**Memorandum  
 Planning and Urban Development Department  
 Planning Division**

**To:** Carol Morrissette, Chair and Members of the Portland Planning Board  
**From:** Jean Fraser, Planner  
**Date:** December 14, 2012  
**Re:** Mixed Use Development at 321 Commercial Street; Level III Site Plan/Subdivision, J B Brown & Sons, Applicant.  
**Project #:** 2012-615      **CBL:** 40-E-3  
**Meeting Date:** December 18, 2012

Foundry Lane looking toward Commercial St

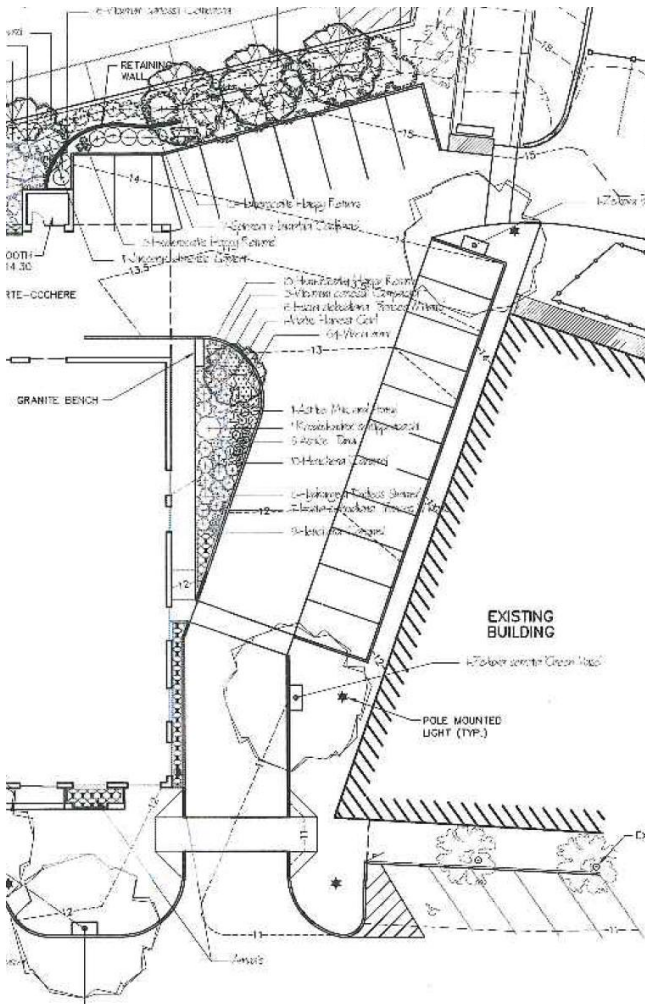
The existing pedestrian path near York Street comprises a brick paved 12 foot wide pedestrian path (edged with cobbles) that currently ends where the vehicle drive from Baxter Place enters the site (photo above).

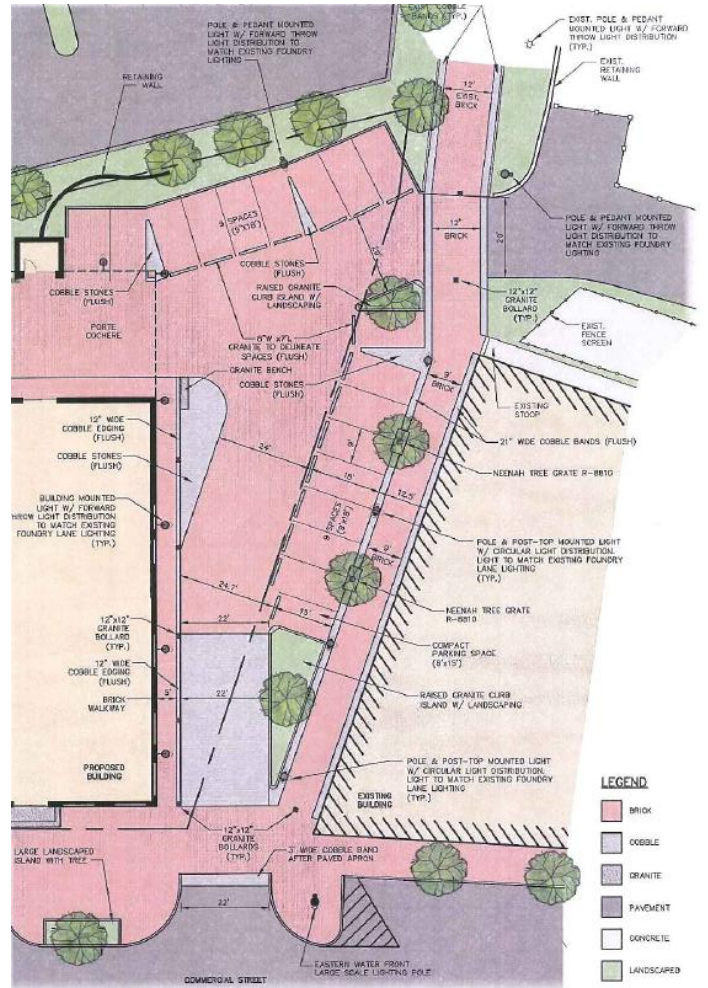
At the first workshop the proposal included bicycle parking and a bench where the existing path ended at the site boundary and added a 5 foot wide brick paved section extending to Commercial Street between the Baxter Building and the proposed parking spaces (Site Plan 6 and above left). At the workshop the Planning Board encouraged the applicant to more clearly continue the scale of the existing path to Commercial Street, based on the following concerns as outlined in the 11.13.2012 PB Memorandum:

- The Historic Preservation Board “Regarding Foundry Lane, Board members noted that its treatment at the top of the block, done as part of an earlier project, was very successful in that it preserved the memory of the historic alleyway and created an attractive pedestrian corridor. They felt it was important that this treatment continue on the lower portion of Foundry Lane to the extent possible.” (Attachment 8) (Note: updated comments are included under **Historic Resources**)

- The existing four street trees (shown on Plans 2 and 4) are replaced with two trees in small grates and this appears to be an opportunity for some larger scale landscape treatment that is consistent with the historic context and meets stormwater management and site landscaping objectives;

- DPS has commented: *A pedestrian easement is shown on the south side of the former Foundry Lane. A sidewalk is now proposed on the north side of the former Foundry Lane. Will a new easement be necessary? The discontinuance does not call for a Pedestrian Easement. Is there a recorded document which defines it as a Pedestrian Easement? (Attachment 4)*

- The Transportation reviewer comments: *The 11 parking spaces on the former Foundry Lane do not appear to meet City dimensional standards. A waiver will be required. I would also note that there is general concern about pedestrian accessibility in this area and modifications to the plan may be necessary (Attachment 7).*

At a follow-up meeting with the applicant to consider the above concerns/comments (also see Attachment P), the applicant proposed the layout shown on page 9, which incorporates a 9 foot wide brick path edged with cobbles and revised parking, planting and lighting. The consulting Traffic Engineer has confirmed (Attachment 15):

*Status: The applicant has submitted a revised plan and the design details indicate waivers will be required. I support waivers from the City's Technical Standards given the desire to provide a dedicated pedestrian facility leading to York Street. I have reviewed the responses from the applicant on comments as it relates to the access to the compact vehicle parking space and a narrow aisle width. I find their responses to be reasonable and as noted above support waivers from City standards.*

The revised plan for Foundry Lane addresses recent comments and the development review staff consider the proposal is broadly acceptable in terms of site plan requirements because it:

- Considerably widens the pedestrian path (to 9 feet wide) linking the existing path to Commercial Street;
- Introduces cobbles and granite bollards to delineate parking spaces and break up the extent of brick paving;
- Incorporates more street trees with reasonable soil area and protection;
- Incorporates lighting to integrate with existing lighting.
